City of Ketchum

August 10, 2021

STAFF REPORT KETCHUM PLANNING AND ZONING COMMISSION

- PROJECT:** City-initiated Text Amendments to Title 17, Zoning, to amend Section 17.12.040 Dimensional standards, CC District Matrix, to modify the fourth-floor setback for projects where 100% of the residential units are community or workforce housing, amend Section 17.140.090 B and C Exempt Communication Facilities, to exempt public safety antennas and any wireless communication facility located on a public use building and amend the City of Ketchum Official Zoning District Map to change the zoning of Block 1 of the Warm Springs Ranch Large Block Plat from T-Tourist designation to GR-L, General Residential Low Density.

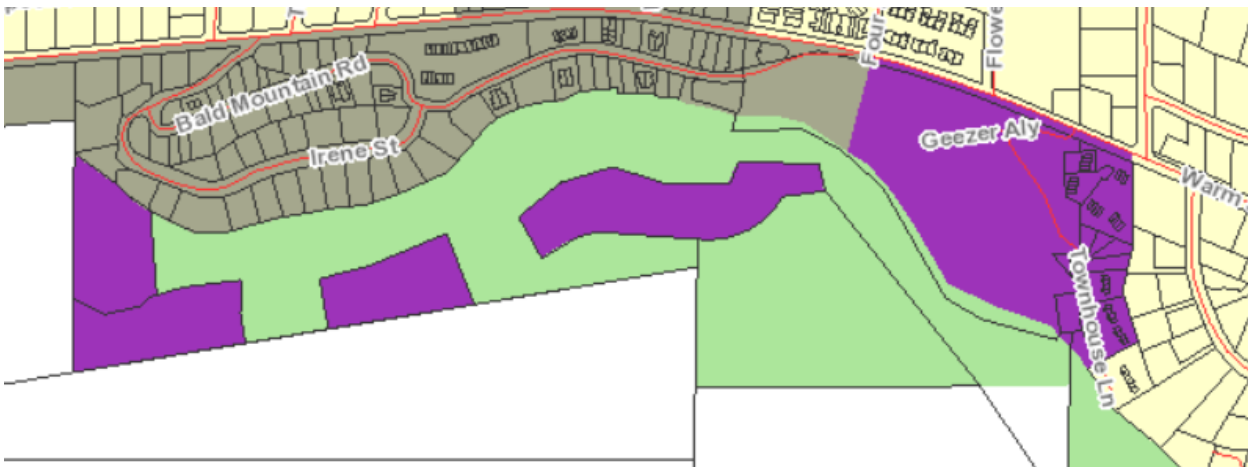
This proposed amendment is a procedural action to reflect the rezoning approved by the Commission and City Council for the Warm Springs Ranch Block 1. Block 1 of Warm Springs Ranch was rezoned from (T) Tourist Zone to GR-L General Low Density Residential as part of the approved Development and Rezoning Agreement. This proposed action officially changes the zoning district map to reflect the rezoning. The Official Zoning District Map would be changed as follows:

Existing (T) Tourist Zoning Designation

Proposed (GR-L) General Residential Low Density Zoning Designation
